State of New Jersey  
DEPARTMENT OF ENVIRONMENTAL PROTECTION  
DIVISION OF HAZARDOUS WASTE MANAGEMENT

Re: Shieldalloy Metallurgical Corporation  
Revised Remedial Investigation Work Plan  
December 7, 1989

The Department has completed a review of the Revised Remedial Investigation Work Plan (RIWP) dated December 7, 1989 and has the following comments.

NEW JERSEY DEPARTMENT OF ENVIRONMENTAL PROTECTION  
 MONITOR WELL SPECIFICATIONS FOR  
 CONFINED UNCONSOLIDATED AQUIFERS

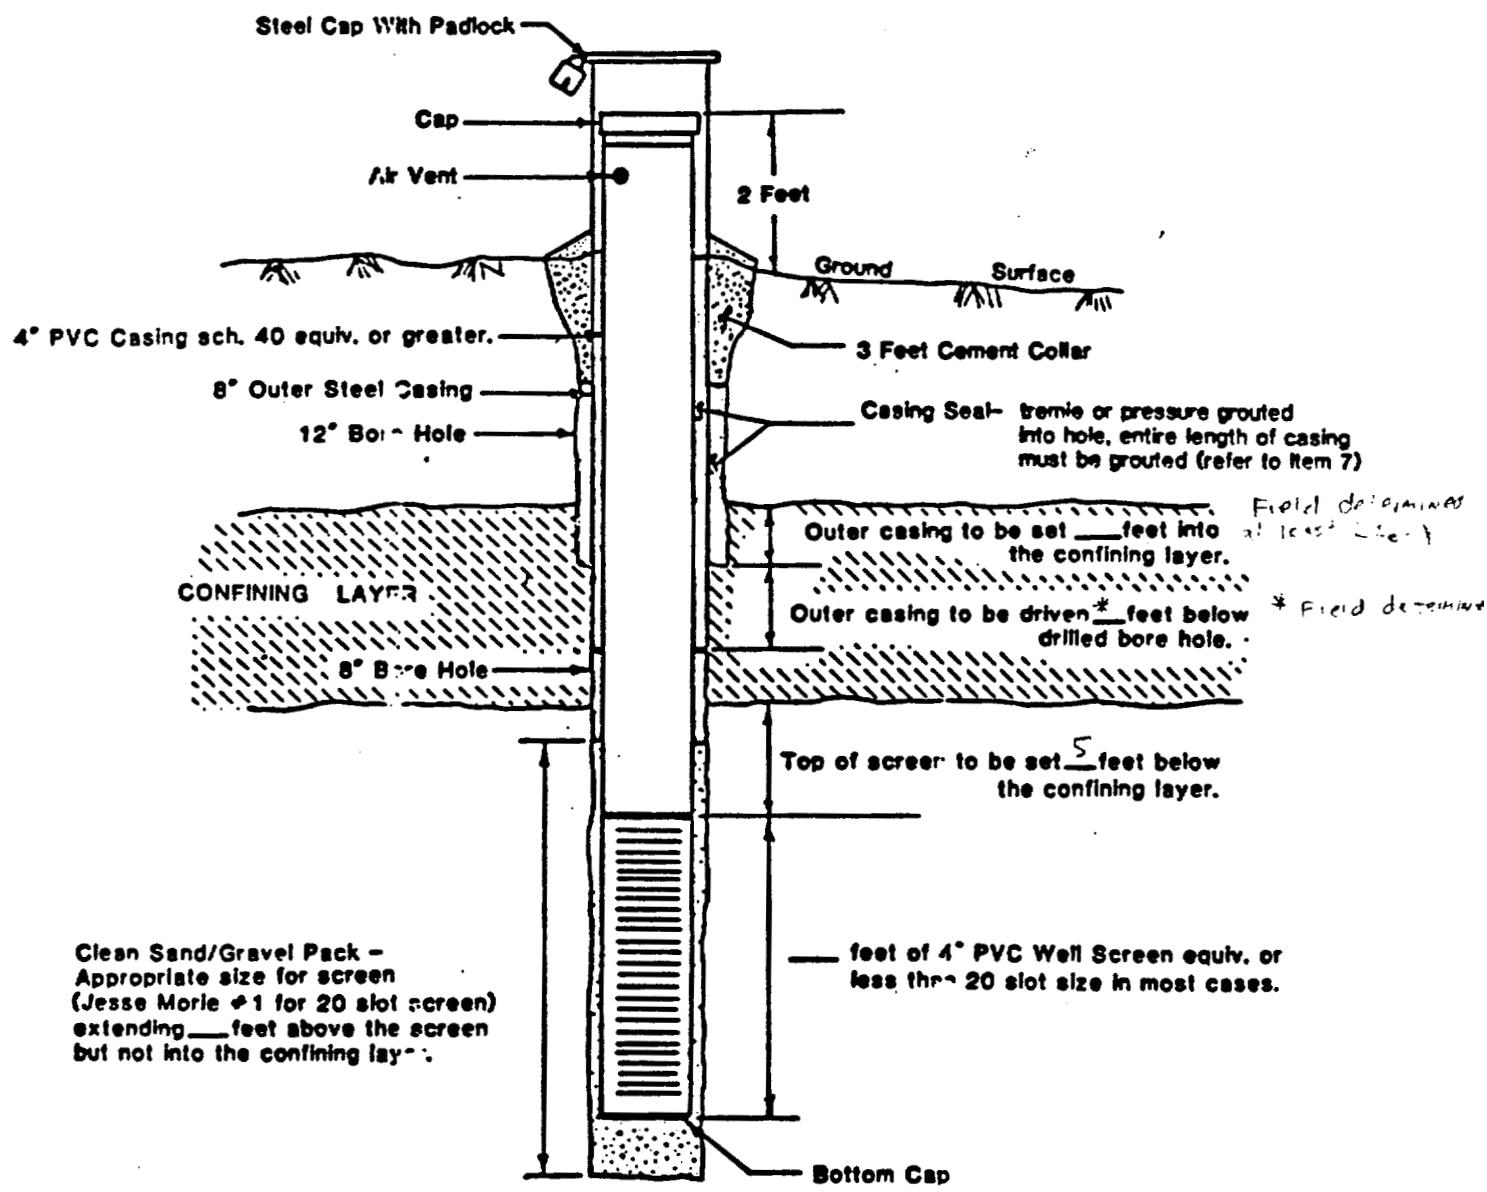
- c. All deep wells installed through confining or semi-confining units shall be constructed according to confining well specifications (see Attachment 2).

MONITORING WELL REQUIREMENTS FOR CONFINED UNCONSOLIDATED AQUIFERS  
Revised 12/87

**NEW JERSEY DEPARTMENT OF ENVIRONMENTAL PROTECTION  
MONITOR WELL SPECIFICATIONS FOR  
CONSOLIDATED FORMATIONS**

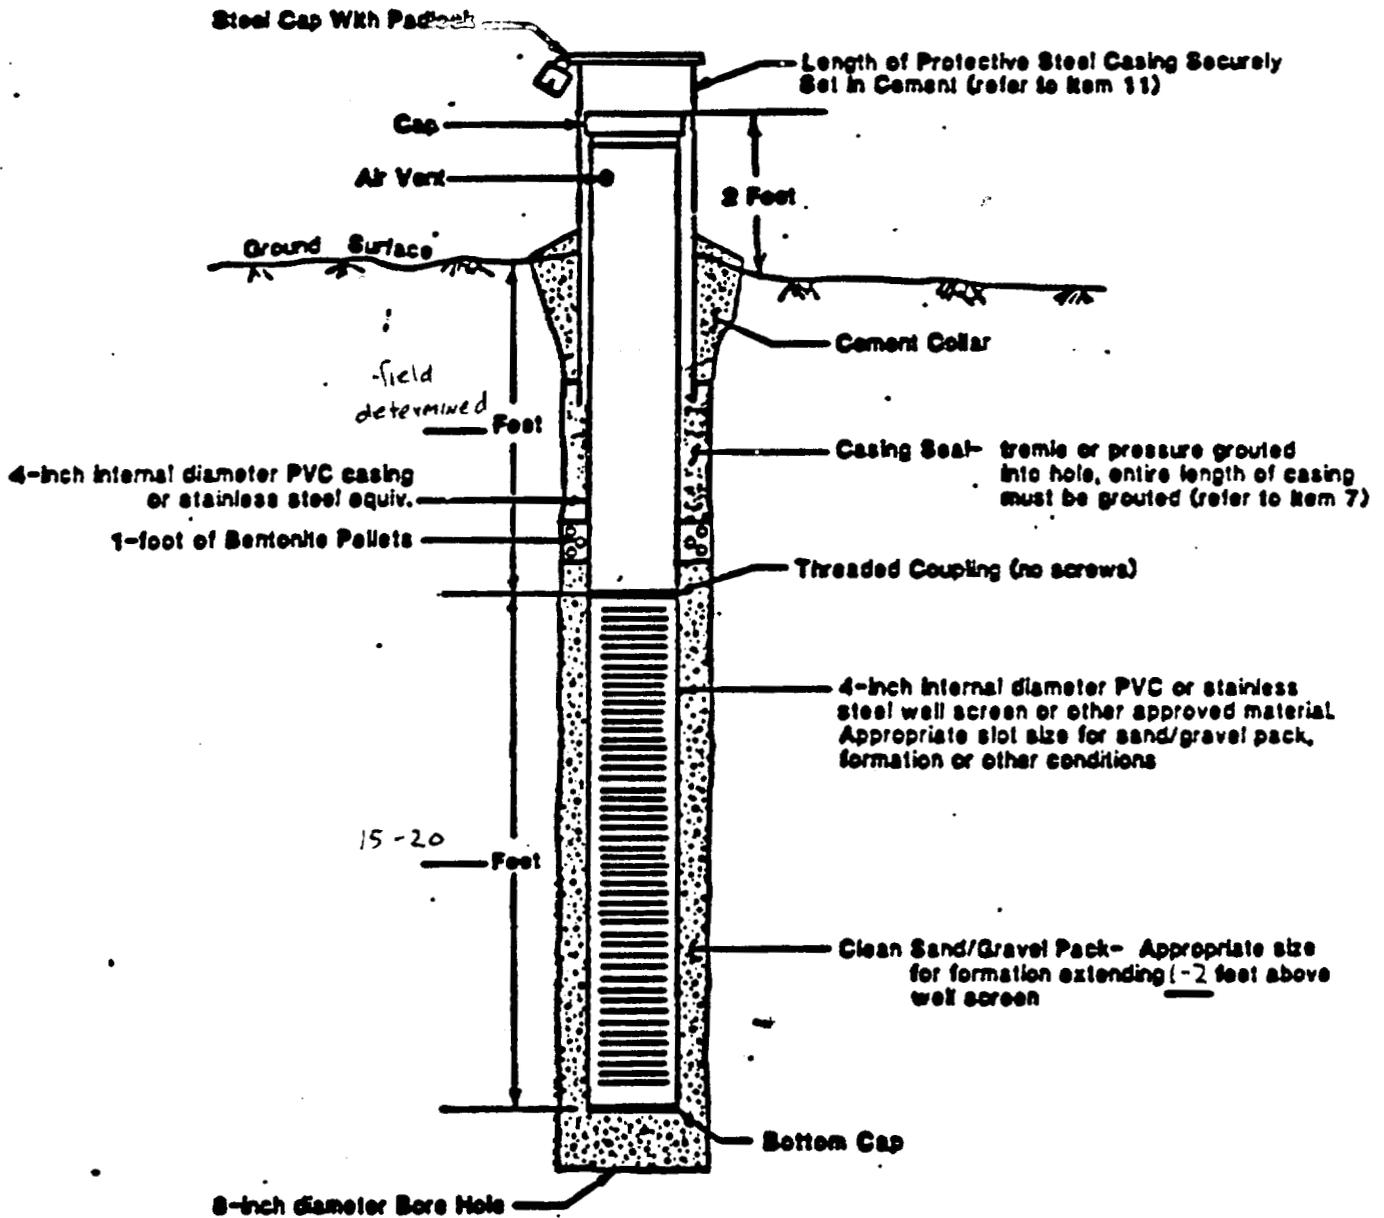
- d. All shallow wells shall not breach confining units and shall be installed in accordance with the Department's specifications (see Attachment 3).
- e. The deep wells may be installed using mud rotary drilling methods, however, in order to define subsurface litology, split spoon borings must be obtained every five feet or at changes in litology. The wells shall be installed in accordance with the Department's specifications (see Attachment 3).

**MONITORING WELL REQUIREMENTS FOR UNCONSOLIDATED FORMATIONS**  
Revised 9/87
